# Electrical
# Miscellaneous Schedules

RIVERSIDE ROAD PUMP STATION
UPGRADES
575 RIVERSIDE ROAD, ROSWELL GA. 30075

ADDENDUM NO.
4

| Instrumentation Control System Block Diagram | |

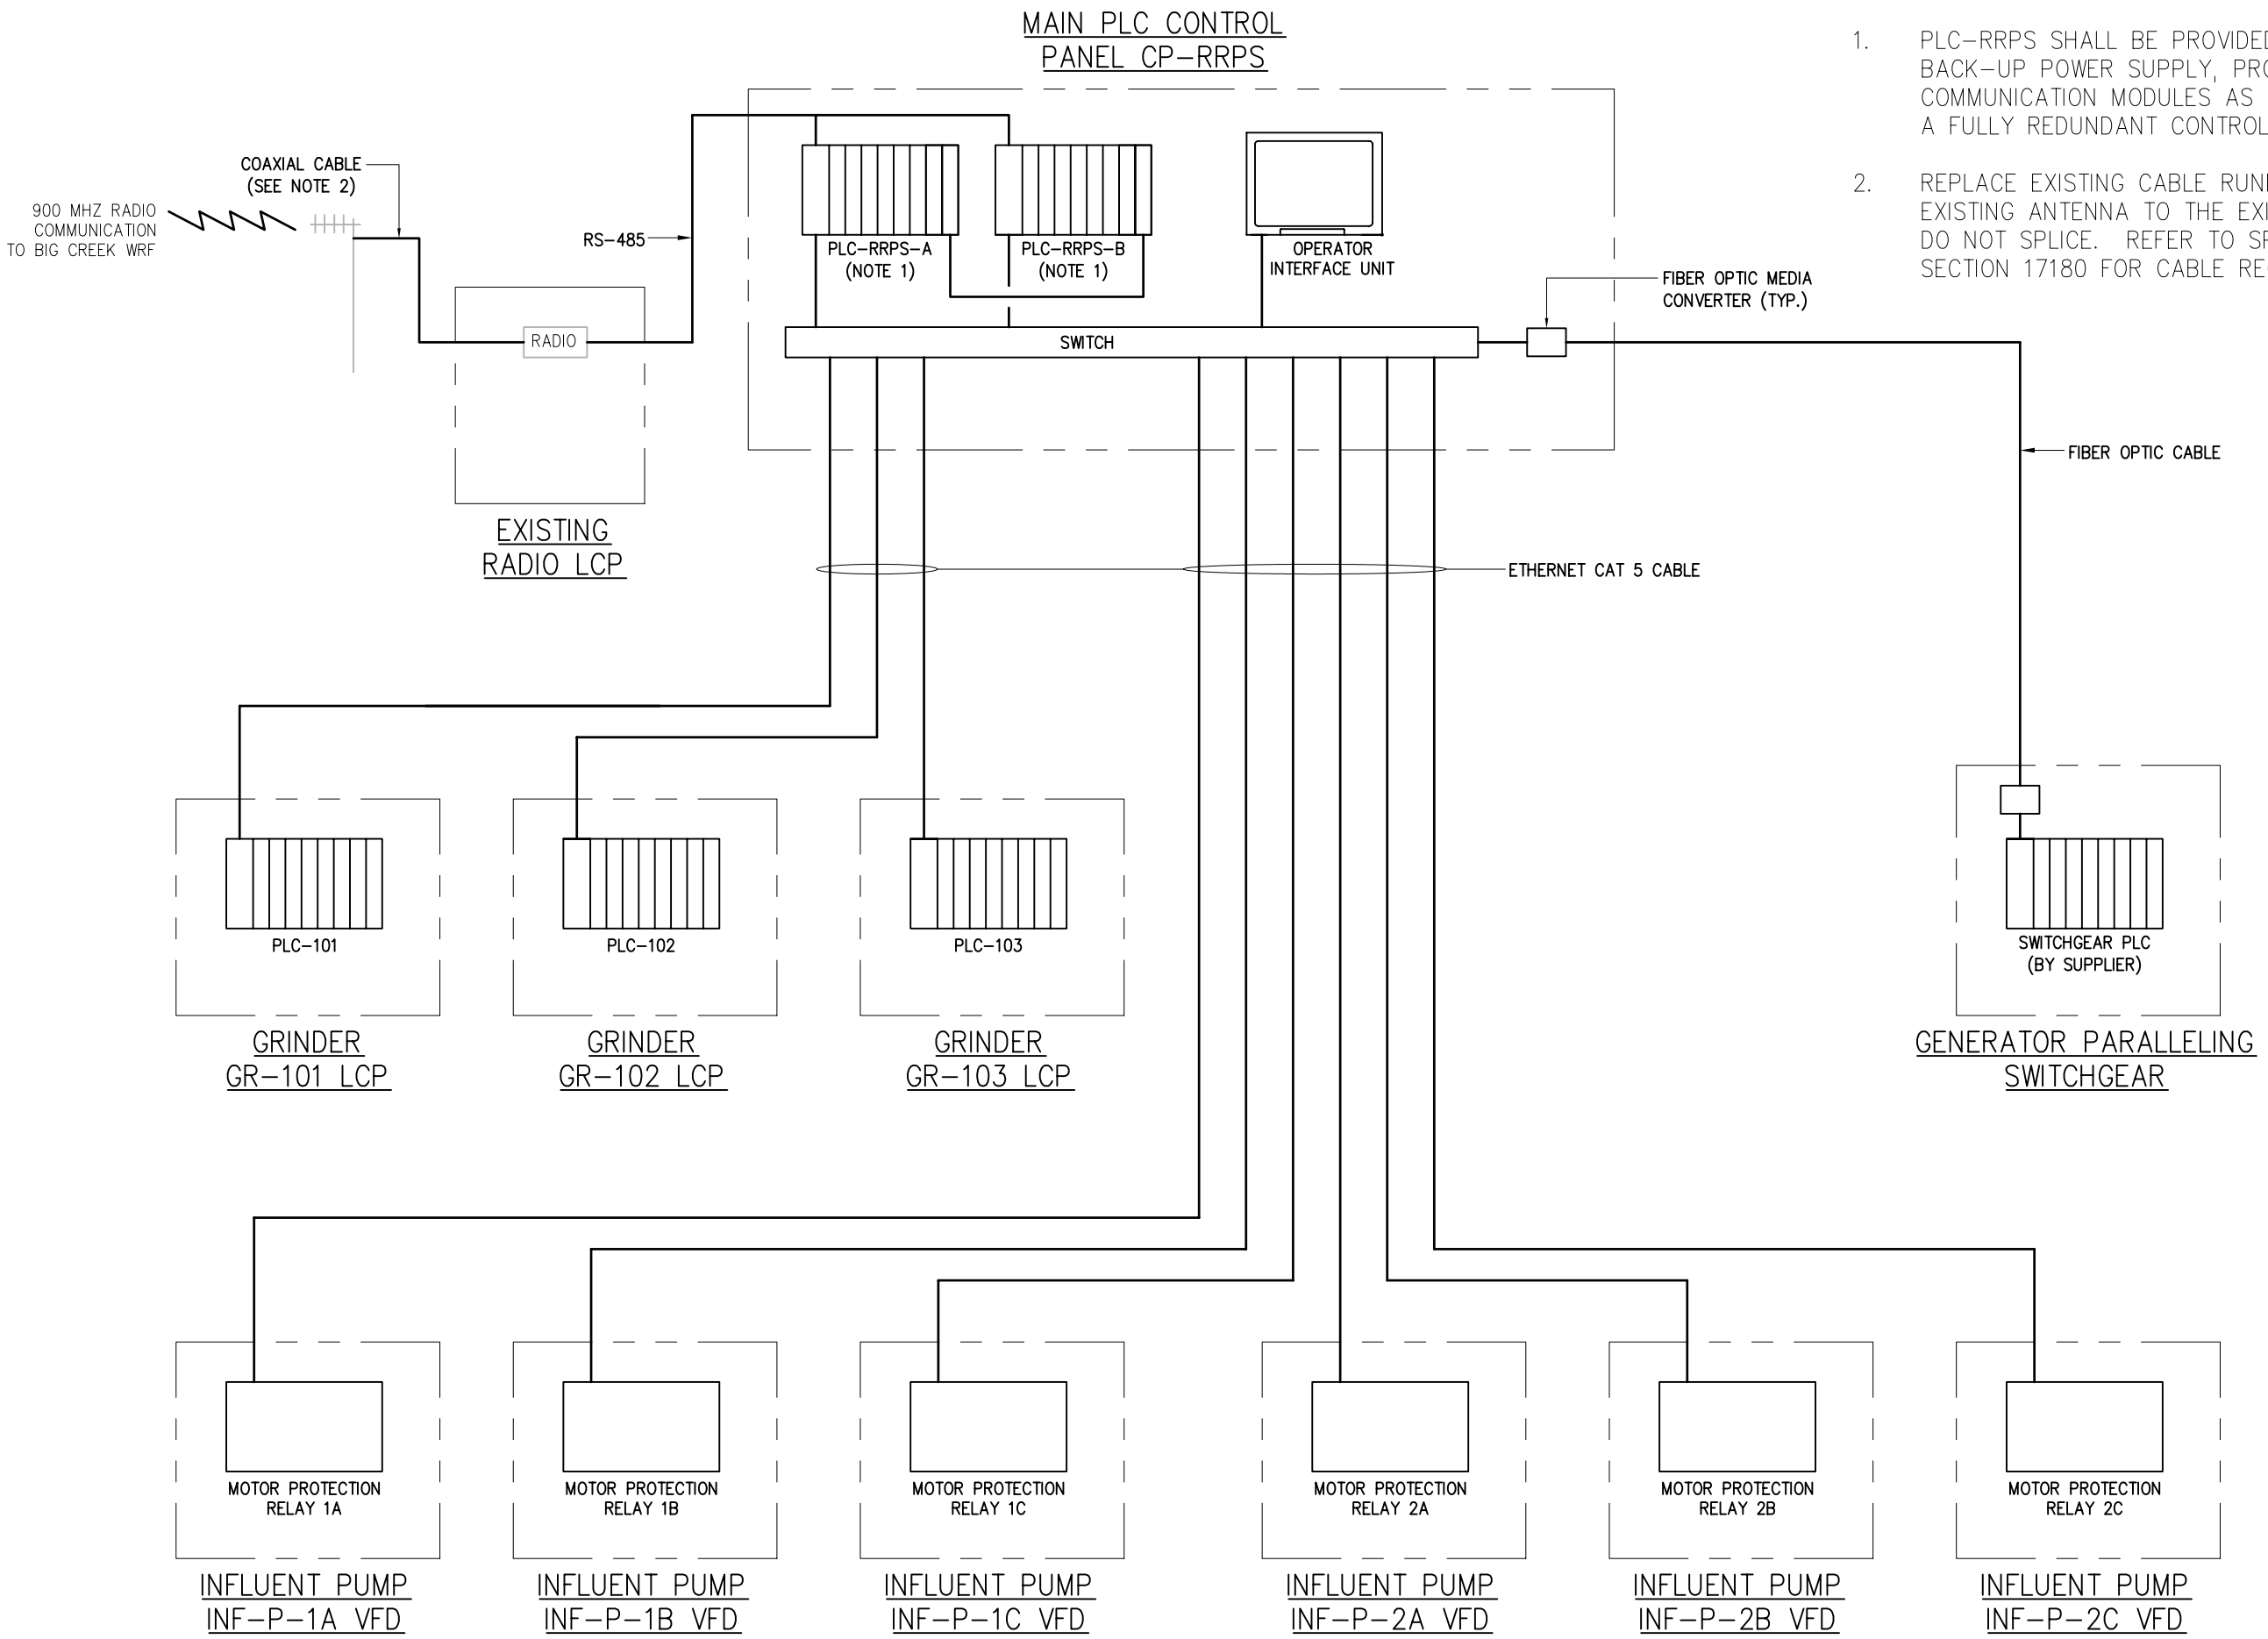
1. PLC-RRPS SHALL BE PROVIDED WITH HOT BACK-UP POWER SUPPLY, PROCESSOR, AND COMMUNICATION MODULES AS REQUIRED FOR A FULLY REDUNDANT CONTROL SYSTEM.
2. REPLACE EXISTING CABLE RUNNING FROM EXISTING ANTENNA TO THE EXISTING RADIO. DO NOT SPLICE. REFER TO SPECIFICATION SECTION 17180 FOR CABLE REQUIREMENTS.

| ADDENDUM NO. | DATE | Instrumentation Influent Grinders and Wetwell Mixing P&ID | H & S JOB NUMBER | REFER TO CONTRACT DRAWING NUMBER |

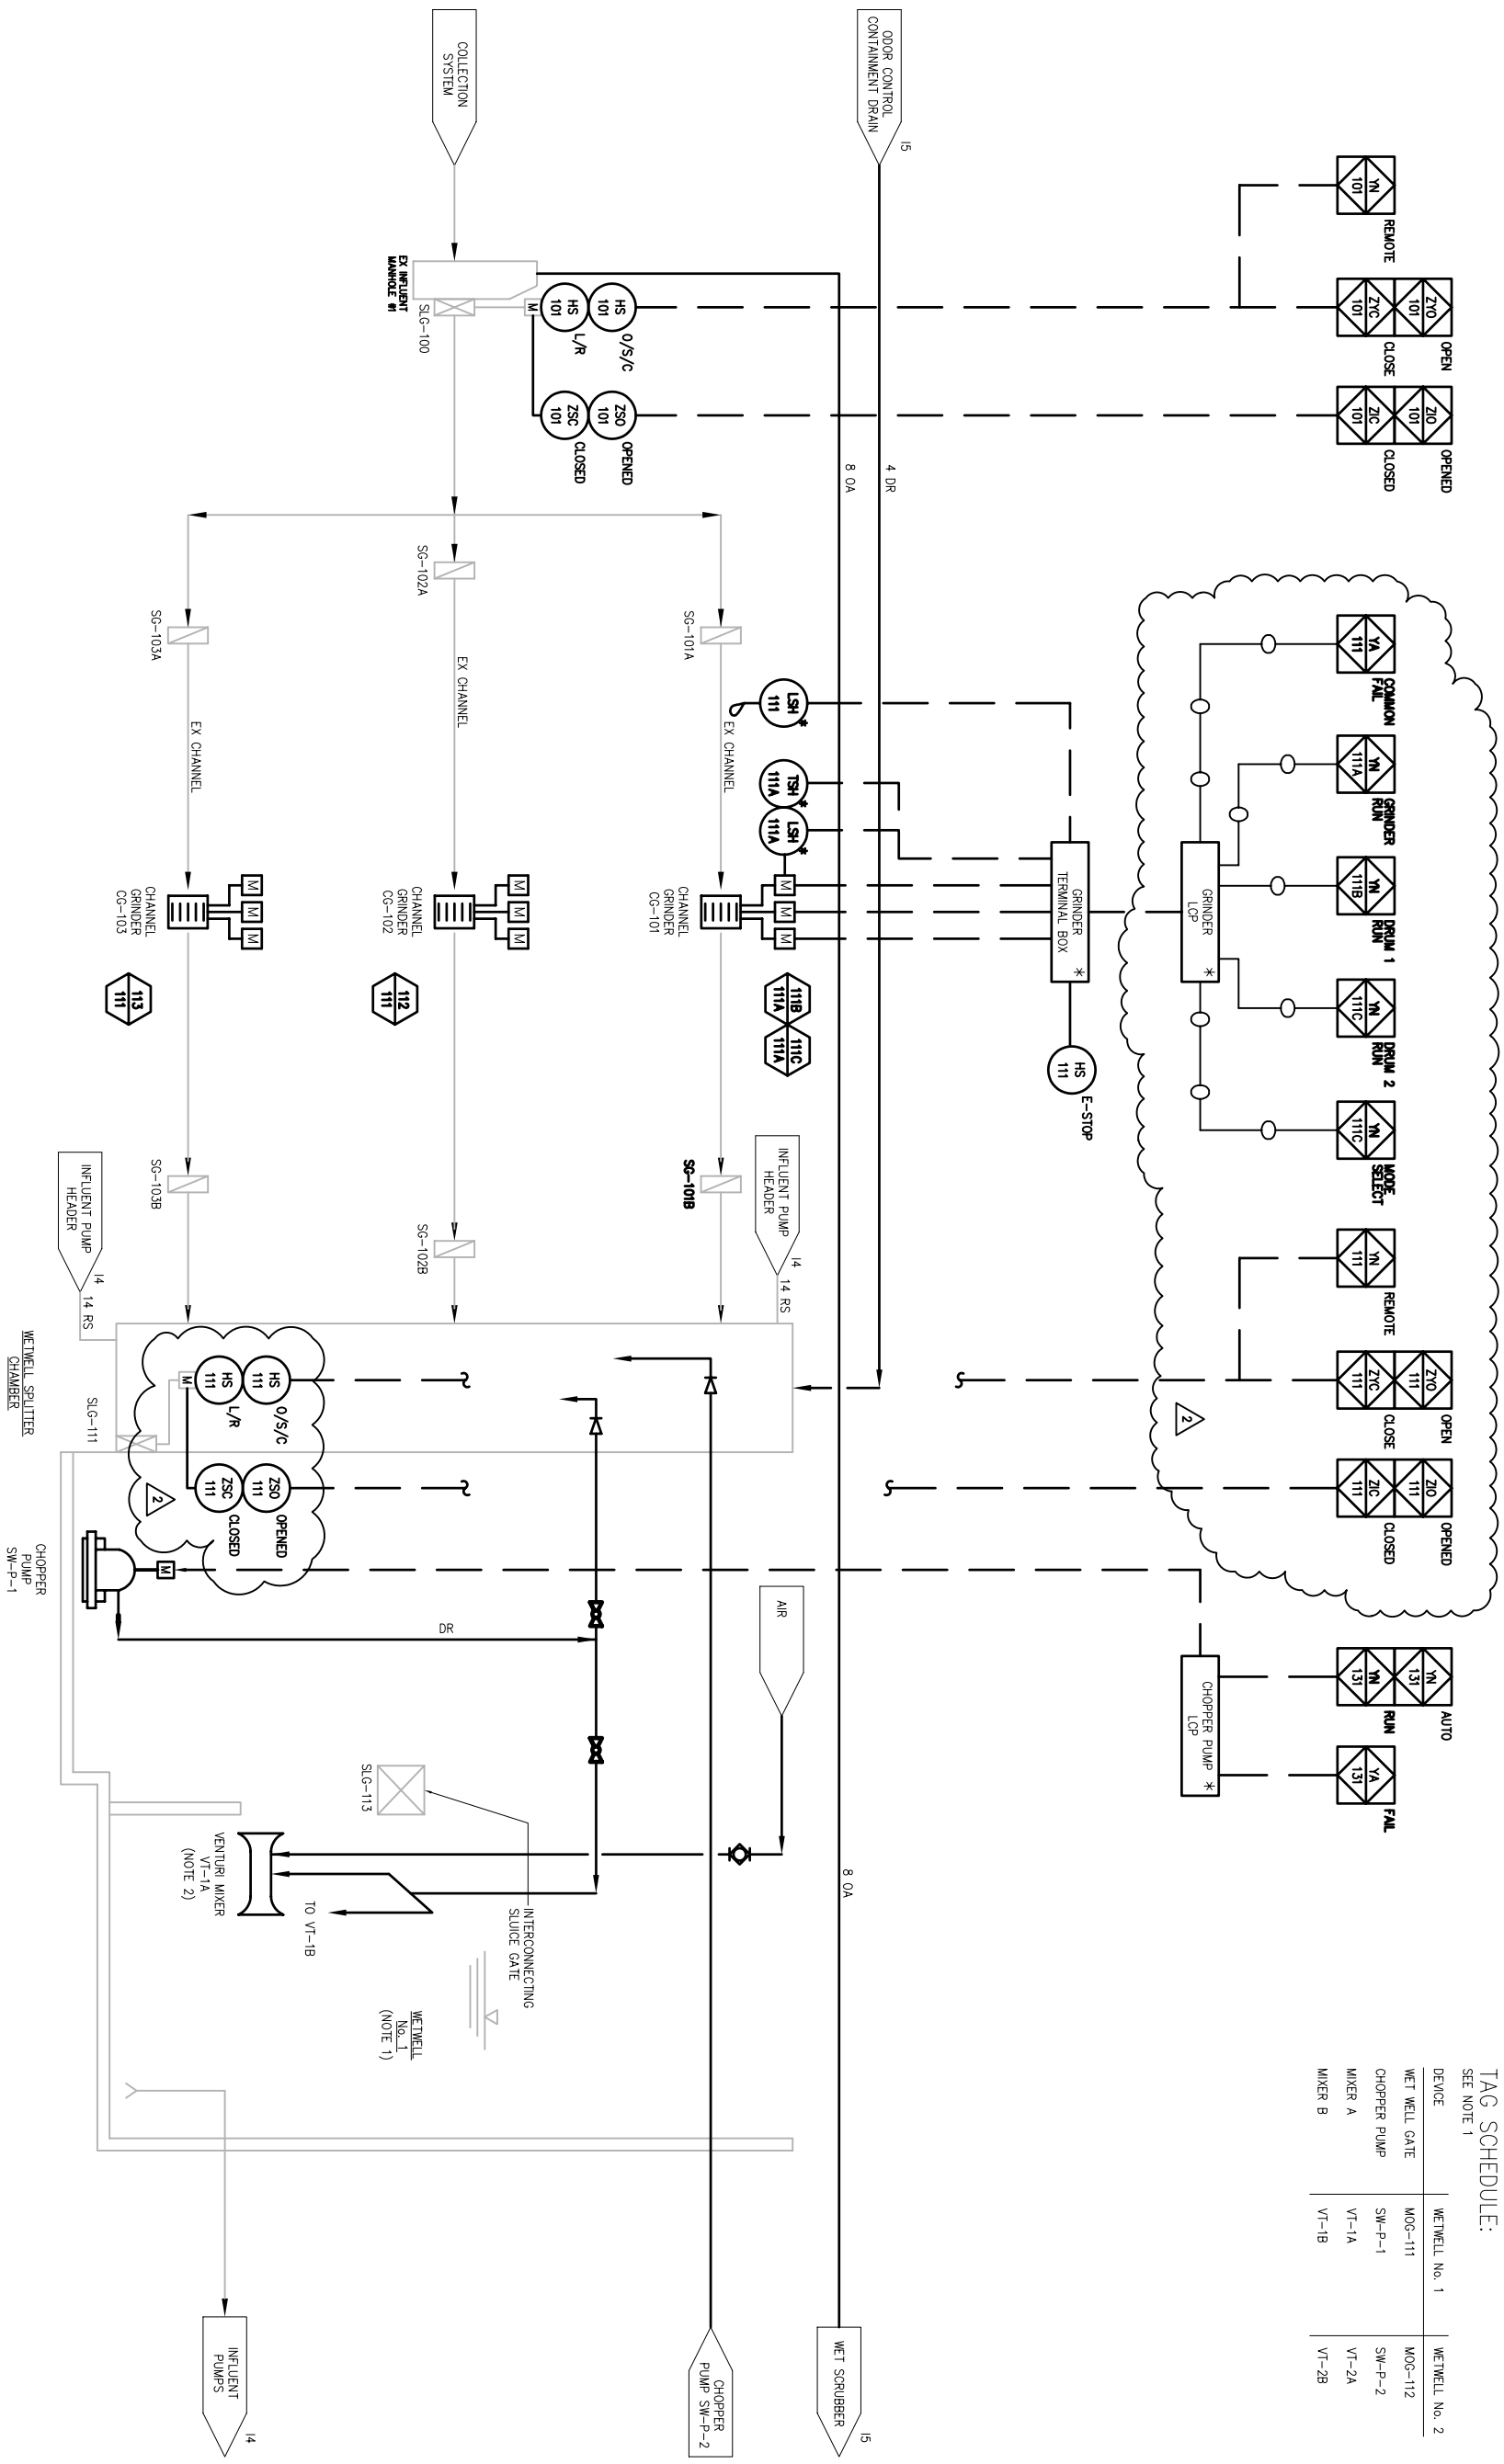
1. WETWELL No. 2 NOT SHOWN FOR CLARITY. EQUIPMENT AND DEVICES AT WETWELL No. 2 ARE IDENTICAL TO EQUIPMENT AND DEVICES AT WETWELL No. 1 (SEE TAG SCHEDULE FOR EQUIPMENT AND DEVICES AT WETWELL No. 2).
2. VENTURI MIXING SYSTEM CONSISTS OF TWO VENTURI MIXERS PER WETWELL. SECOND MIXER NOT SHOWN FOR CLARITY.
